Technical Service Bulletin

SUBJECT:			No: TSB-20-15-002
ABNORMAL NOISE FROM EXHAUST HANGER			DATE: November 2020
			MODEL: 2014-20 Mirage, Mirage G4,
CIRCULATE TO:	<input type="checkbox"/> GENERAL MANAGER	<input checked="" type="checkbox"/> PARTS MANAGER	<input checked="" type="checkbox"/> TECHNICIAN
<input checked="" type="checkbox"/> SERVICE ADVISOR	<input checked="" type="checkbox"/> SERVICE MANAGER	<input checked="" type="checkbox"/> WARRANTY PROCESSOR	<input type="checkbox"/> SALES MANAGER

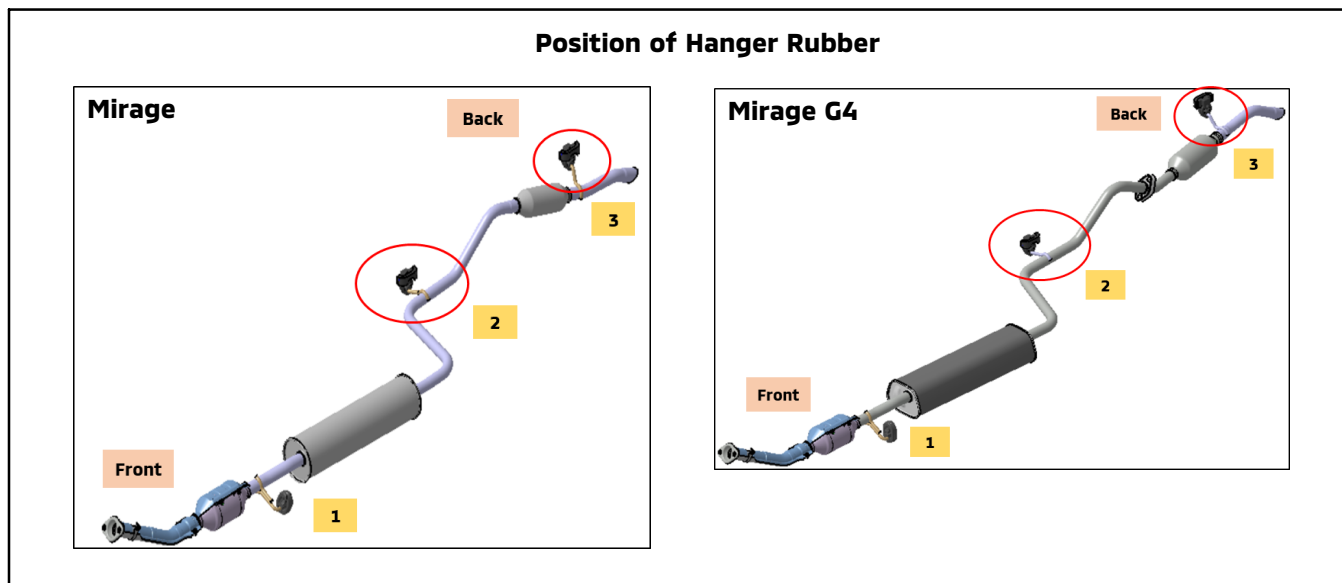
A customer may complain of an abnormal noise coming from the exhaust area while driving. This may occur due to vibration between the exhaust hanger and body side bracket. As the vibration intensifies, the gap at the damper increases in size and the hanger hits the bracket creating an abnormal noise.

Replace the Exhaust Muffler Hanger with the new part number 1577A390 at position 2 and 3 as shown below.

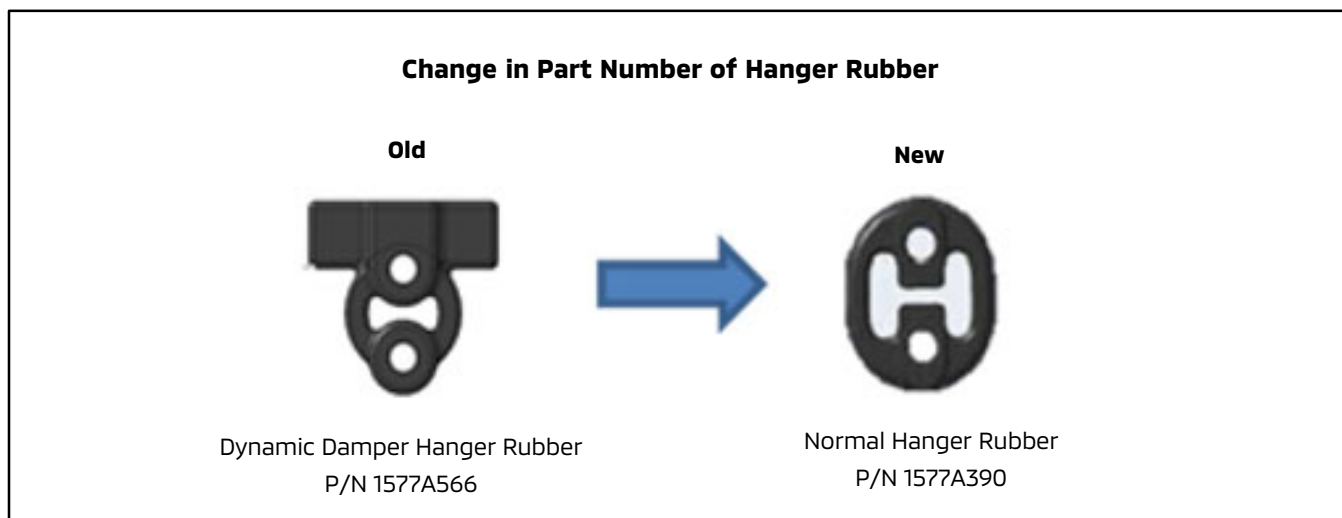
Old hanger (position 3)

New hanger (position 2)
